WATER QUALITY MEMORANDUM

RE: 2006 Fourth Quarter Water Monitoring, PacifiCorp, Trail Mountain Mine, C/015/0009

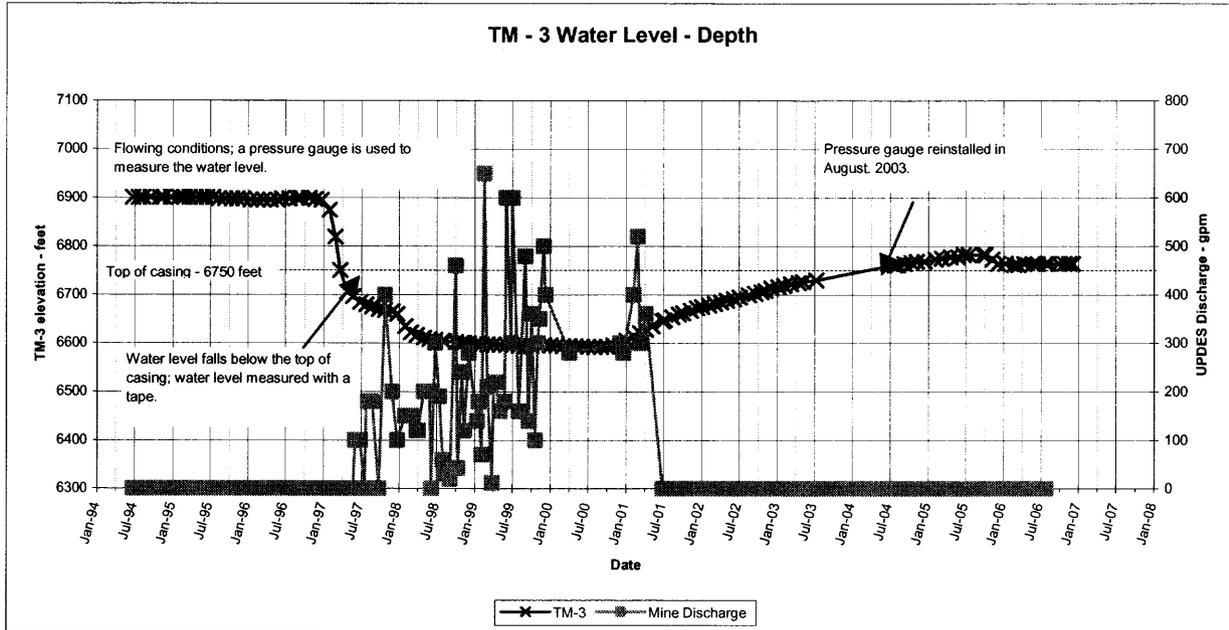
In TM-3, water elevation peaked in June 2005, remained steady through October, dropped 18.5 ft in November and December 2005, and have been steady since. See chart below.

There is no further action recommended at this time.
